**TOWN COUNCIL ACTION ITEM
STAFF SUMMARY
JUNE 16TH, 2020 COUNCIL MEETING**

Ordinance No. 11-20, Series of 2020.

**AN ORDINANCE APPROVING A MAJOR PUD AMENDMENT FOR
THE DILLON URGENT CARE & RESIDENCES PUD DEVELOPMENT
PLAN LOCATED AT 956 W. ANEMONE TRAIL**

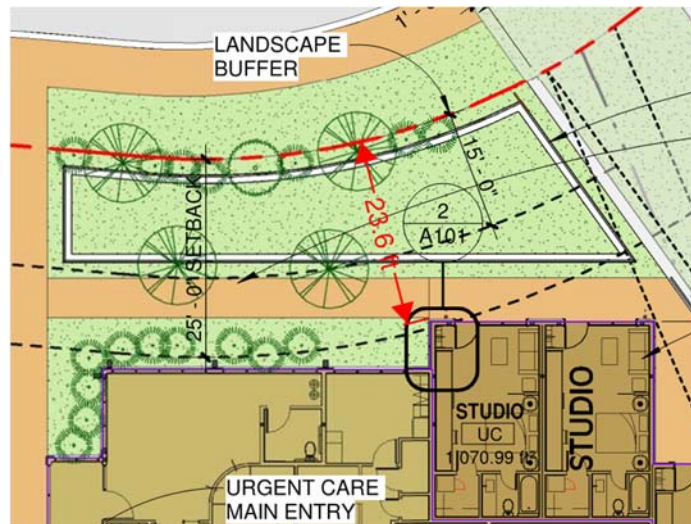
The main change to the proposed site plan is the **addition of a residential driveway** to the north end of the condominium building, along the eastern property line adjacent to the Dillon Dam Brewery development. This driveway will only serve the residential building.

The applicant raised the finished floor elevation of the garage 5', so access through the clinic parking lot is no longer possible. The applicant adjusted the vertical spacing between floors in this building to keep the height of the building below the maximum height allowed in the Mixed-Use Zone district.

The new 20' driveway will be constructed over the new 25' wide sanitary sewer easement located along the northeastern property line. From a sanitary sewer maintenance, grading, and access standpoint, this arrangement is desirable to the Town.

A small boulder retaining wall will be built along the dam brewery property line and the road will sit below the elevation of the shared property line. This arrangement will

prevent snow from being plowed onto the Dam Brewery property.

Approved 2019 Landscape plan at the rear of Lot 45B. Showing Trees & Wall.

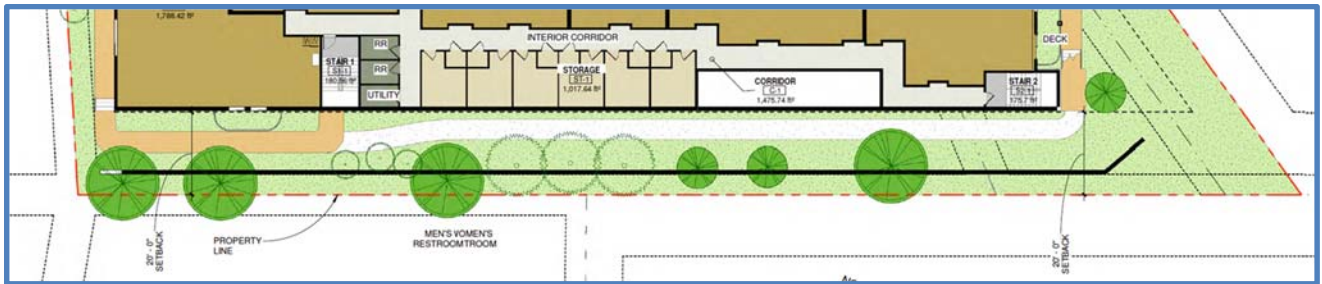
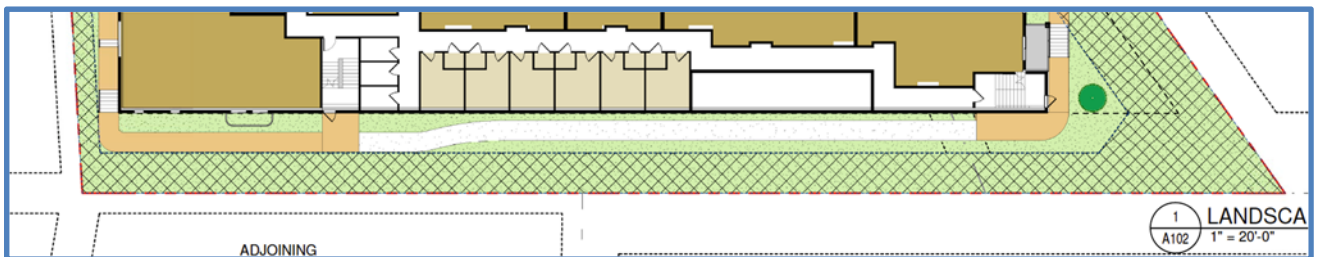
- 6) *REDUCTION in trees provided onsite due to building shift, additional driveway and additional utility easements requested by the Town of Dillon.*

The sanitary sewer main was relocated in the fall of 2019 to a new location along the east property line adjacent to the Dam Brewery. After observing the depth of the existing sewer and contemplating the future reconstruction of the line once Lot 45B develops, Town staff required the developer to grant an additional 10' wide utility easement along the south property line. This unfortunately resulted in the elimination of the trees along the rear property area and the applicant also removed the retaining wall in this area to assist with future maintenance of the public sanitary sewer line.

*Proposed 2020 Landscape plan at the rear of Lot 45B
Showing the required 10' sanitary sewer easement, elimination of wall and trees.*

Proposed 2020 Landscape adjusted for Utilities

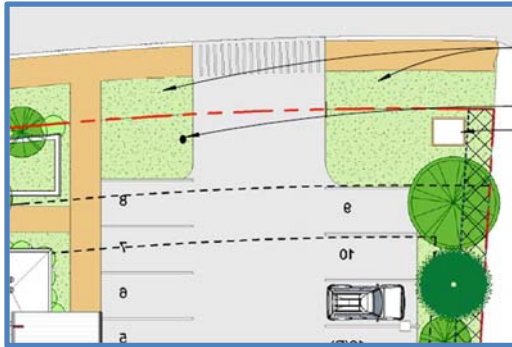
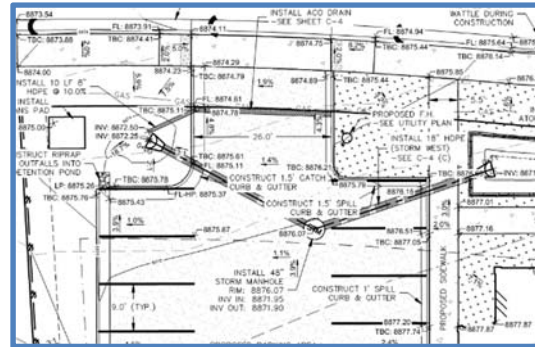
The fire hydrant requirement at the clinic parking lot entrance also resulted in the elimination of trees in the fire hydrant easement.

Utility conflicts at clinic entrance

Along the east property line adjacent to the Dillon Dam brewery, the sewer easement prevented trees from being planted in the first 20'. The trees were placed in an area between the new driveway, clinic building and residential building.

Overall the number of trees proposed have been reduced from 40 to 17.
